Report Nos. 50-317/90-10  
50-318/90-10

Facility Name: Calvert Cliffs

Inspection Summary: Routine Unannounced Inspection on May 14-18, 1990  
(Inspection Report No. 50-317/90-10)

Areas Inspected: An inspection was performed of licensee activities related to engineering modifications. The modifications included FCR 89-24 which was completed and FCR 89-180 which was in process at the time of inspection.

## SERVICE WATER PIPING DIAGRAM

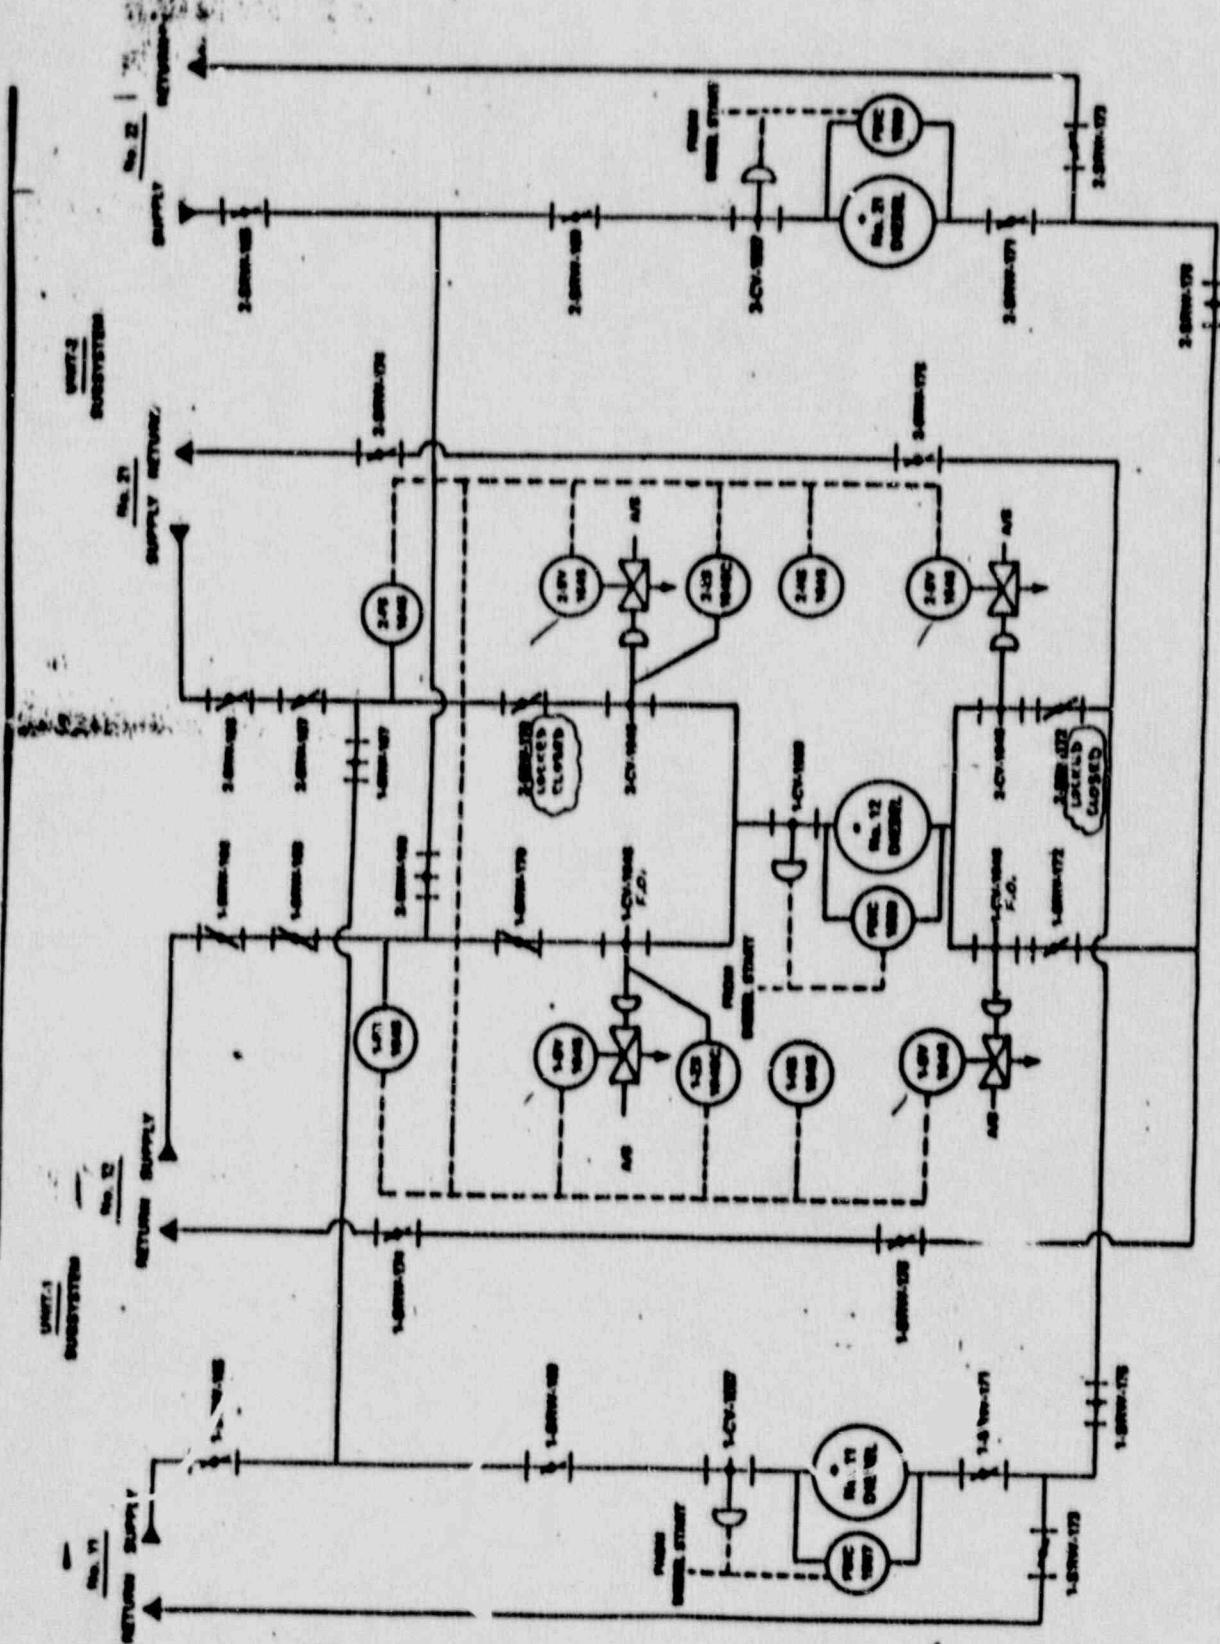
The licensee has in place a temporary modification (1-89-77) to ensure that a service water break in the common header will not affect units 1 and 2. Temporary modification 1-89-77 locks shut 2-SRW-170 and 2-SRW-172. This locked shut condition isolates the unit 2 service water supply at 1-IA-811 and 814. This will enable valves 1-CV-1645 and 1646 to remain open, so that unit 1 service water will supply cooling water to EDG No. 12 or vice versa depending upon the location of the break along the header. This temporary modification will be in place until the permanent modification described in section 3.1 of this report is completed in its entirety.

Attachment A of this report shows a p. & I. D. of the permanent as well as the temporary modification
